Kentucky Transportation Cabinet Value Engineering Study

Mountain Parkway Item No. 10-166.00 Magoffin County

Value Engineering Study Report

Study Dates: May 23-25, 2016

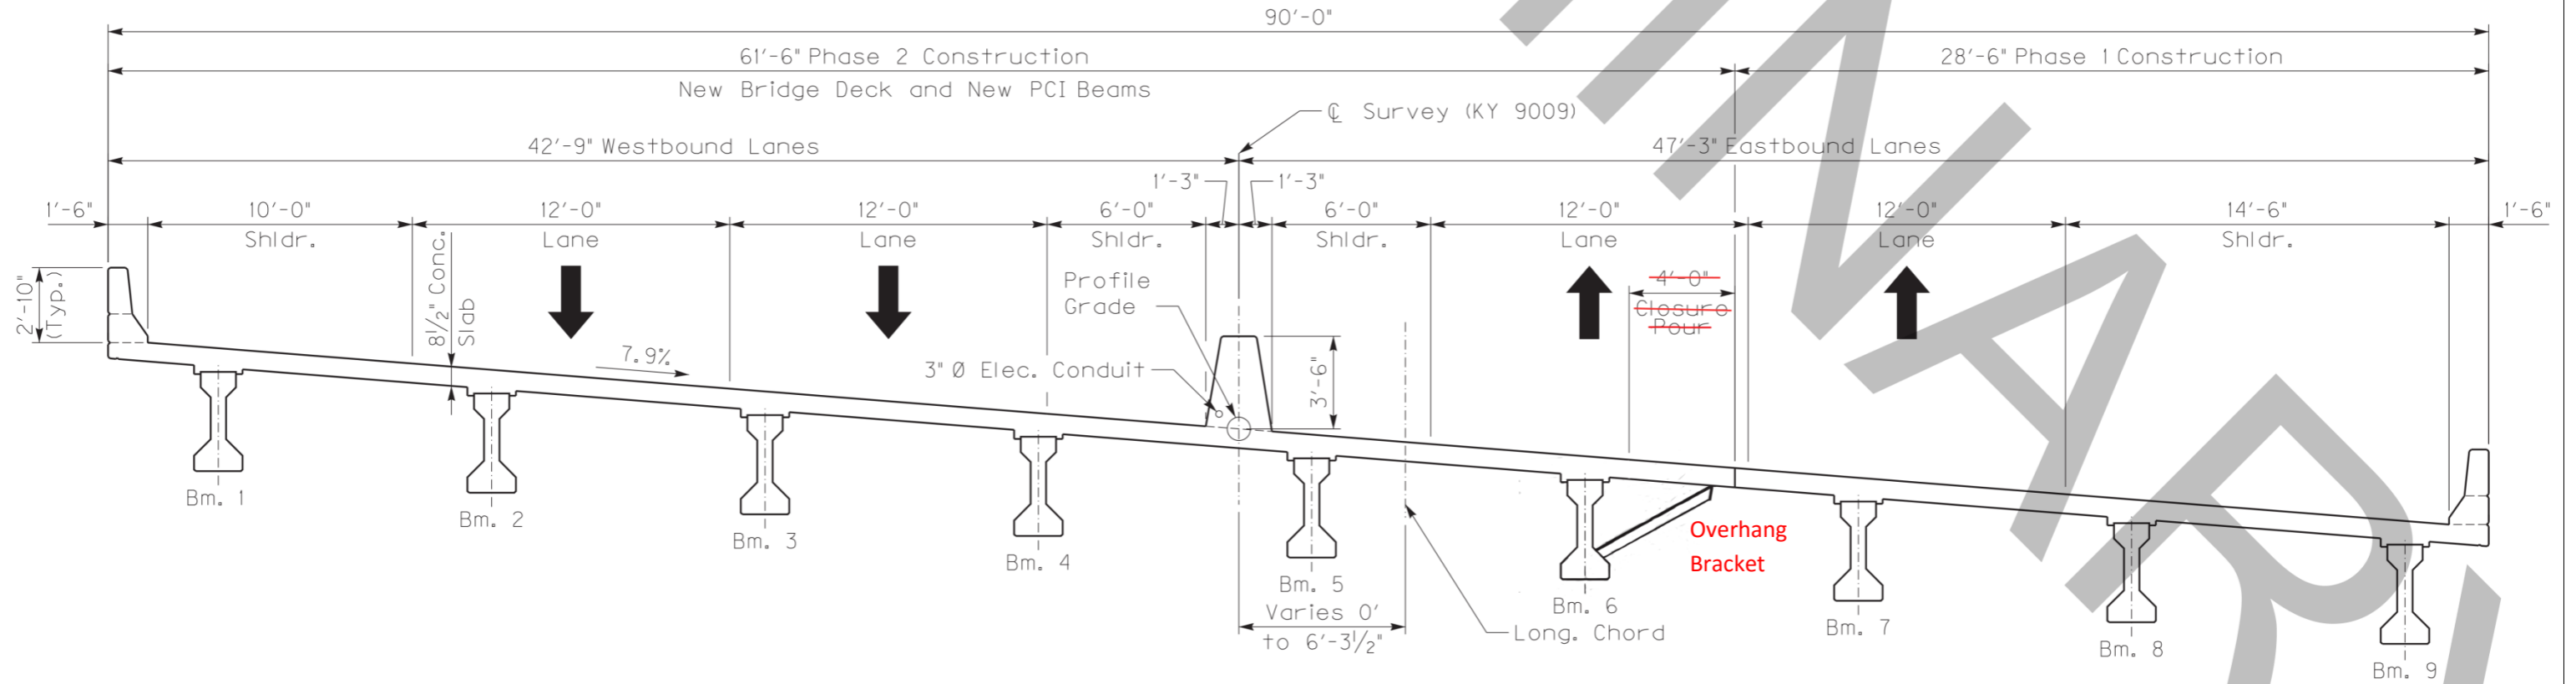
The plans show a 4' closure pour of the deck as the last part of Phase 2 construction. This closure pour will be difficult to form and will add a longitudinal cold joint the entire length of the bridge. An alternate to this closure pour is to place this area as part of the Phase 2 deck pour. Overhang brackets and forms could be used, similar to those shown for Phase 1. There are several issues that may make this alternate difficult. The first issue being the congestion of the overhang brackets used during Phase 1. The plans do not state if the temporary brackets (Phase 1) are needed only for the pouring of Phase 1 or are needed after the concrete has cured. If the brackets are needed after the concrete has cured, additional transverse ("drop-in bars") reinforcement that are lapped with the #6 transverse bars could be added (if reinforcement shown in plans does not work for this overhang length). The other issue with eliminating the closure pour is space and location for the screed machine rail. On past construction projects the screed rail was placed on top of the temporary barrier wall.

Alternate will cause modifications to plans and cost estimate. Costs represent material costs only and not contractors time to complete the work.

VALUE ENGINEERING PROPOSAL EC-21DS
Kentucky Transportation Cabinet
Mountain Parkway Item No. 10-166.00

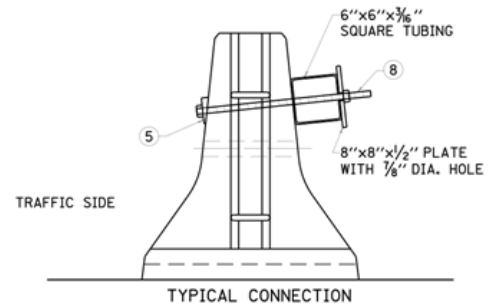
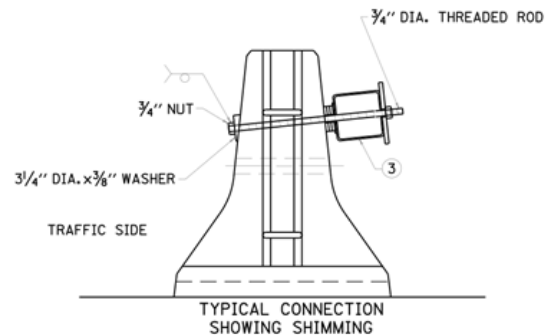
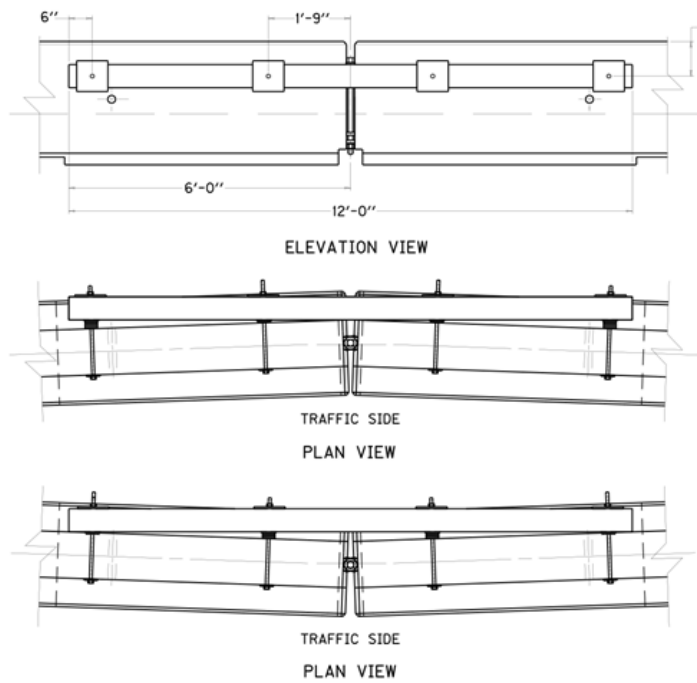
The existing plans shows that the temporary barrier is connected to the deck with 1 1/8" diameter bolts with 2" holes in the deck that is spaced every 4'. KYTC has a standard drawing, RBM-120 that shows a stiffened temporary barrier. Other slight modifications (plate/angle attached with bolts using mechanical couplers already in place of deck and timber) could be used to ensure that the barrier will not slide off the deck. By using the details shown on the Standard Drawing, this would eliminate the holes in the new deck and not allow water and de-icing agents into the new deck.

Alternate will cause modifications to plans.

VALUE ENGINEERING PROPOSAL M-04
Kentucky Transportation Cabinet
Mountain Parkway 10-166.00 Project

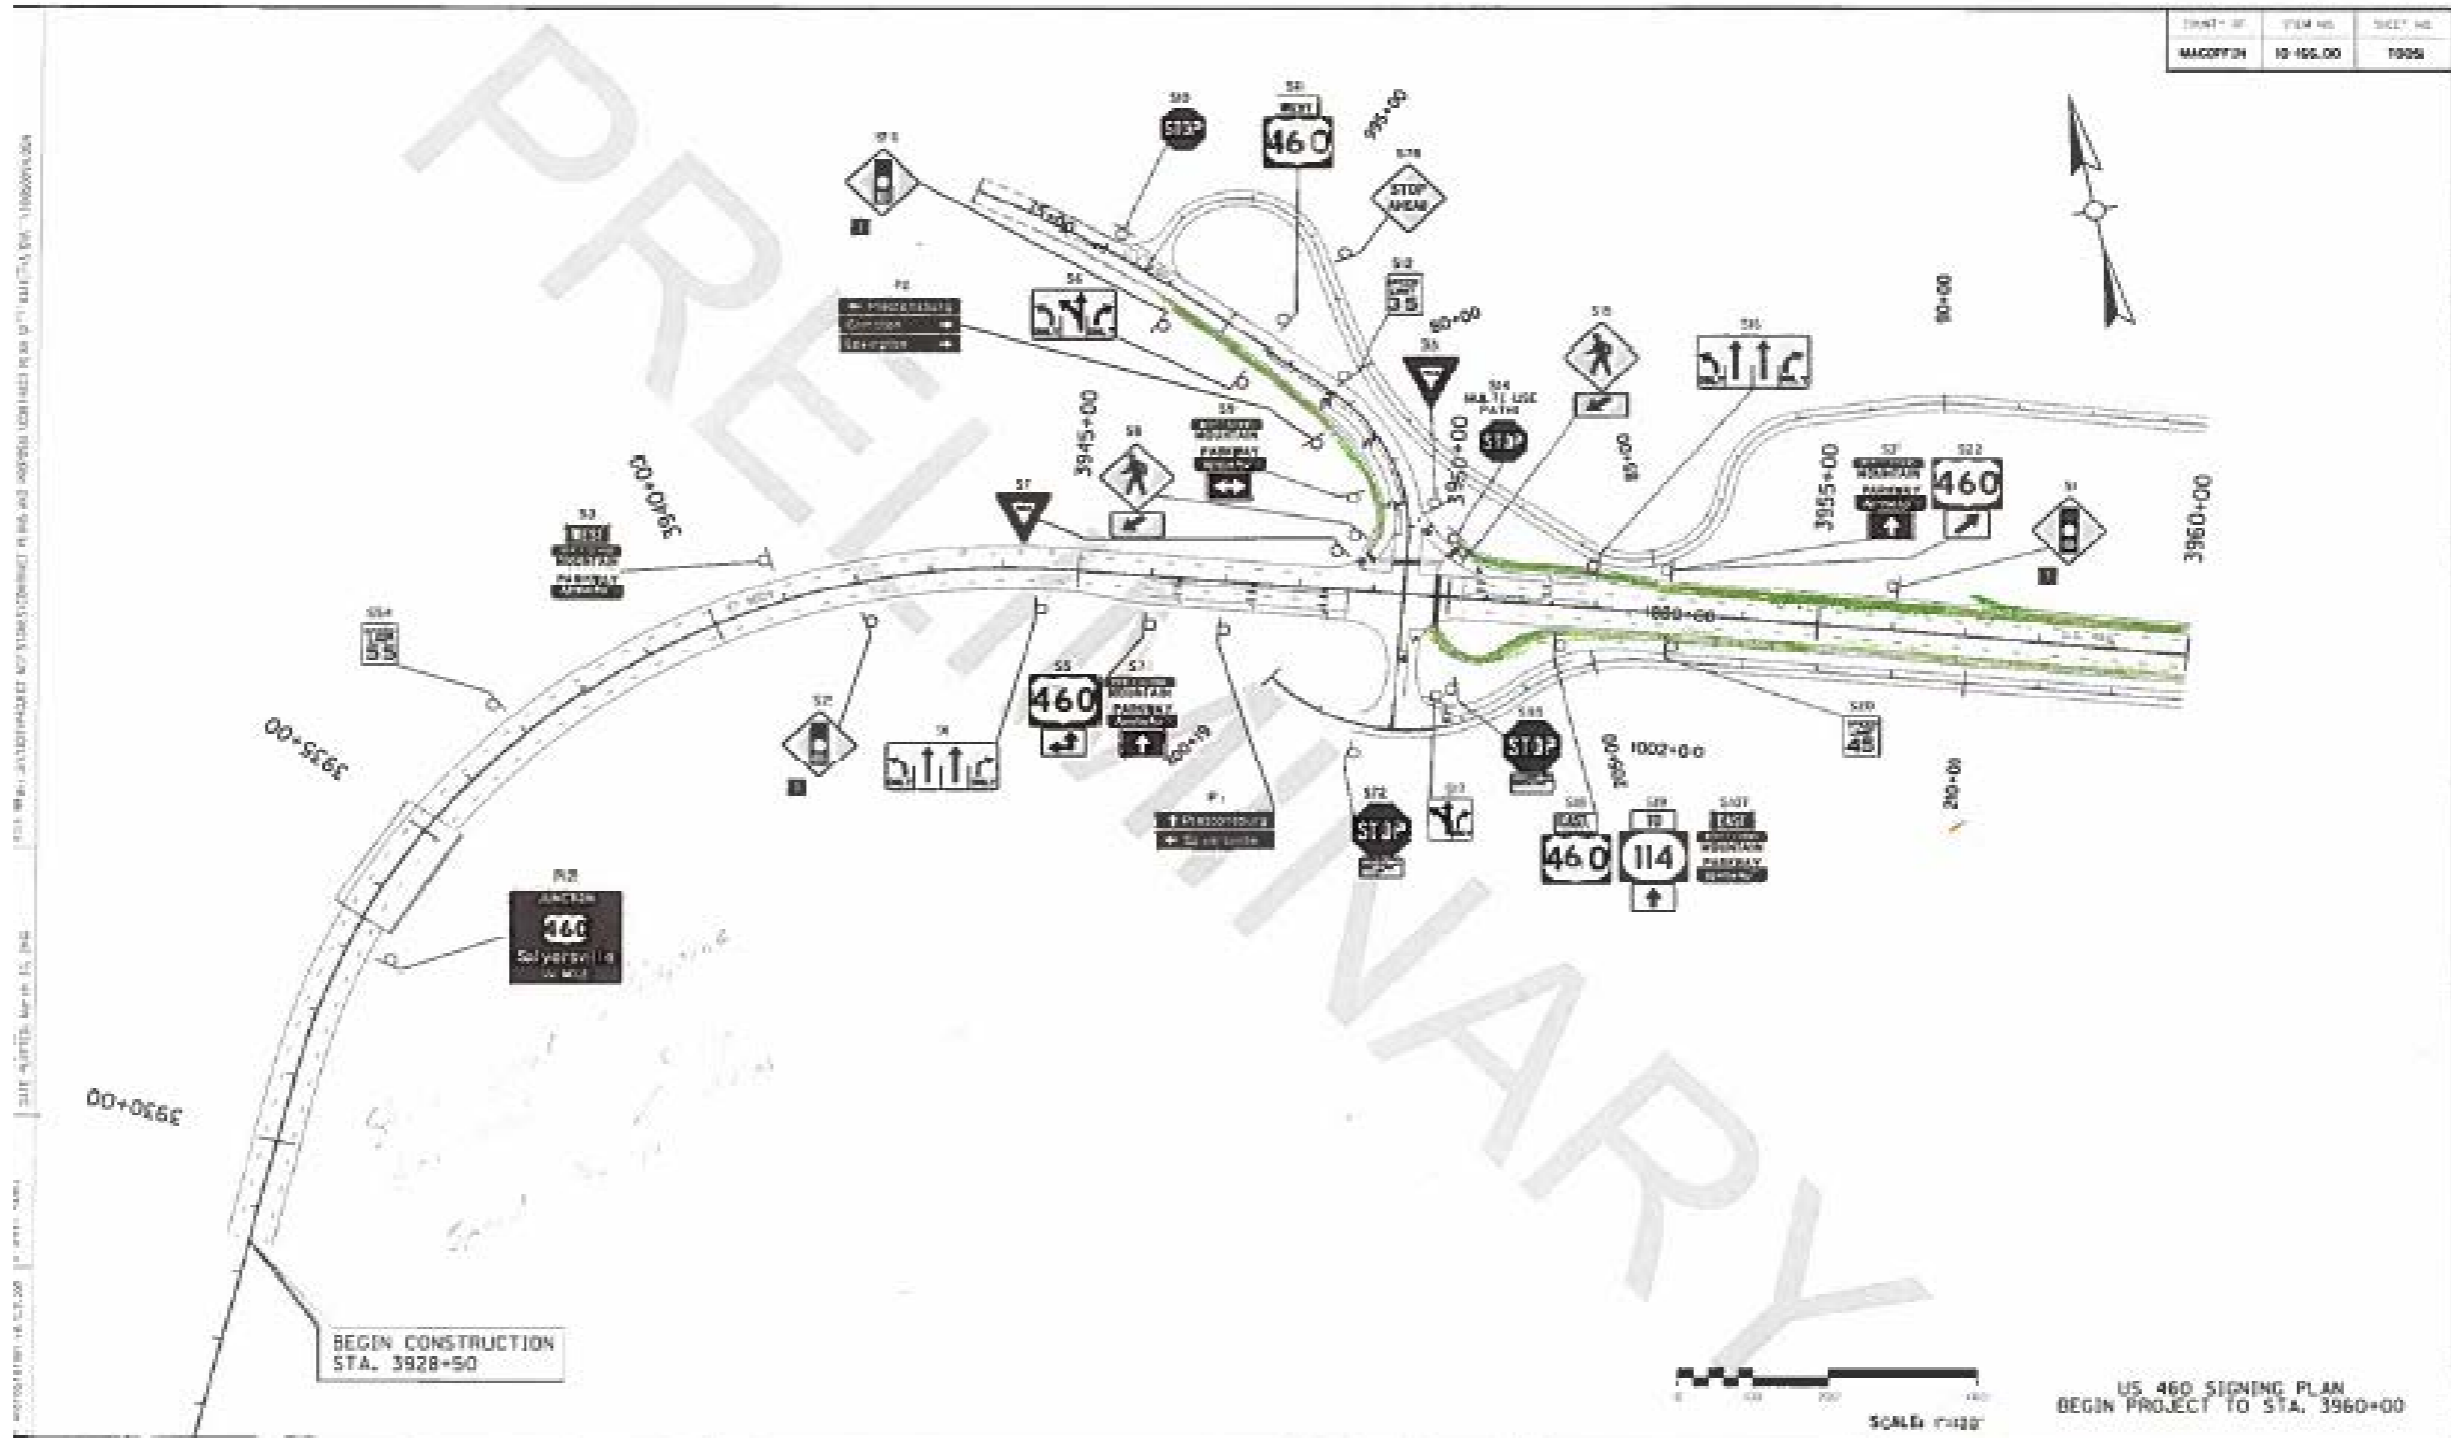
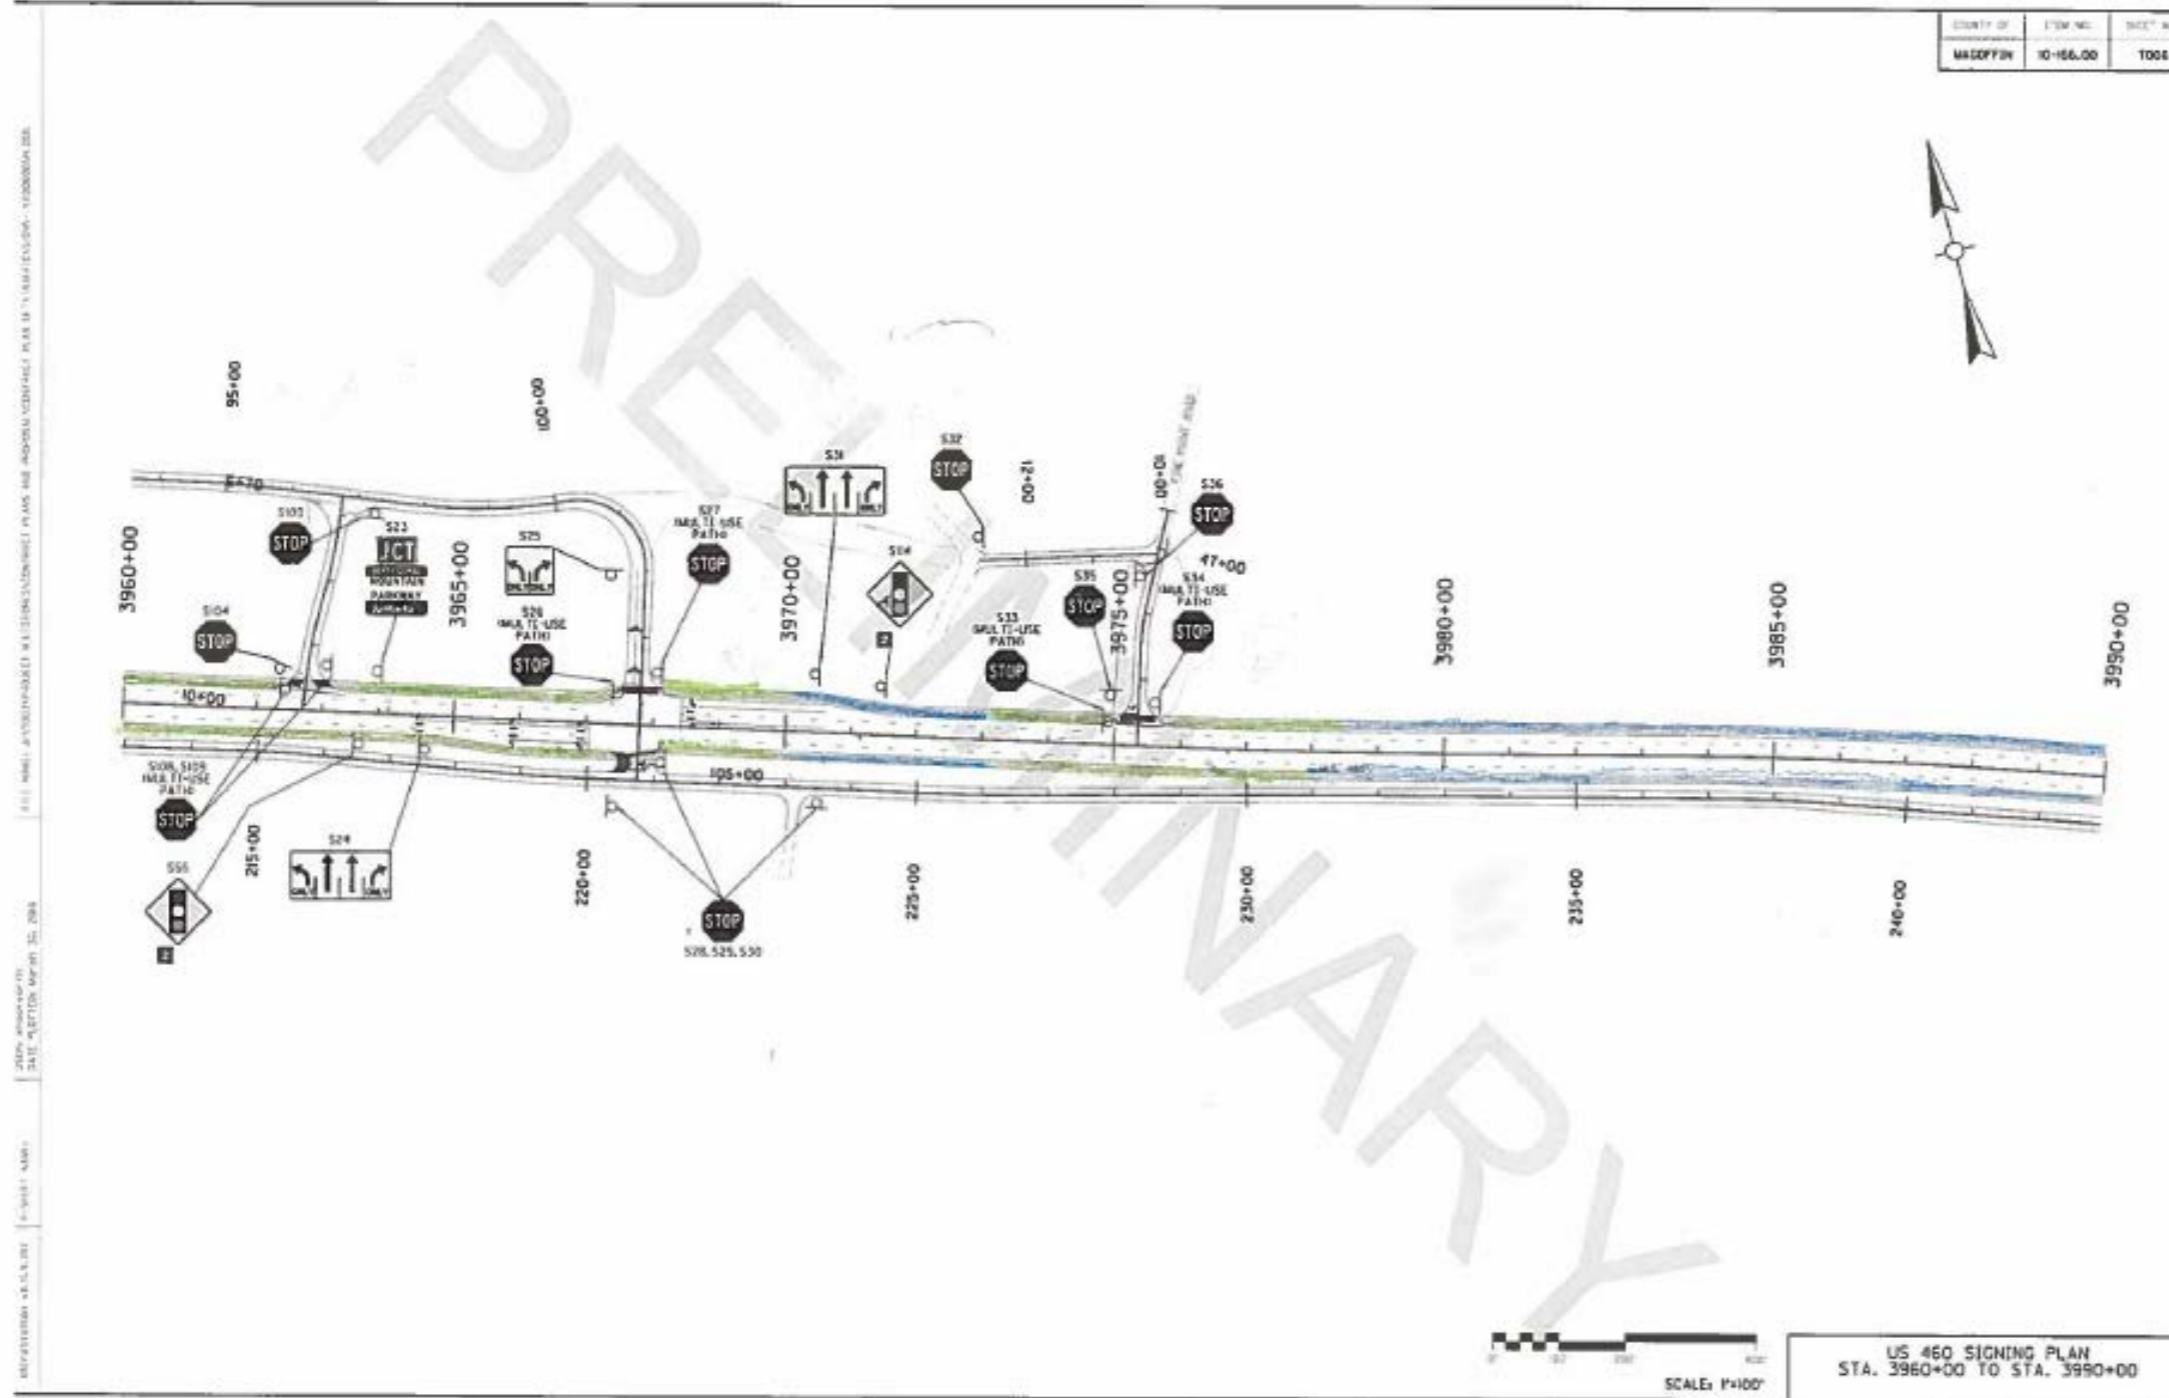
The location for these barriers would be in front of the high school and could be in front of the businesses that have the potential to generate pedestrian traffic. The suggested barrier is a wooden fence or another aesthetically pleasing barrier that fits in with the surroundings.

On the attached layouts, the orange line along the shared-use path channels the students from the high school to the crosswalk, which is the main area proposed. The cost has been calculated based on this approach only. The red line along the sidewalk and shared-use path does the same thing yet it is for the restaurant area of the project. This area is heavily suggested to have a fence like the high school has. The green areas are important areas to have a fence since it keeps pedestrians from crossing and it channelizes them to cross at crosswalks. The blue areas are suggested areas for a fence, yet are not required. The fence should be a woven wire type 1 fence with wooden planks added to the top, middle and bottom on the side facing the parkway or another material that is aesthetically pleasing and mixes well with the context of the area. The installation of the fence should follow section 721 of Kentucky's standard specification for Road and Bridge Construction. If these fences are added to the plans, then there should be a special supplemental note identifying where these fences are to be used. This will ensure that the contractor does not confuse this fence with the installation of regular woven wire type 1 fence.

The fences can be built within the existing right of way, since they are being built in between US 460 and the shared-use path. The major concern would be if the utilities would be impacted by the fence poles, and they do not affect the utilities. This is a concern more for the underground utilities then the above ground utilities. The pole placement is important because it should not affect the underground utilities. In addition, the fence should be built to protect the pedestrians from vehicles that go off the road and the fence should be aesthetically pleasing.
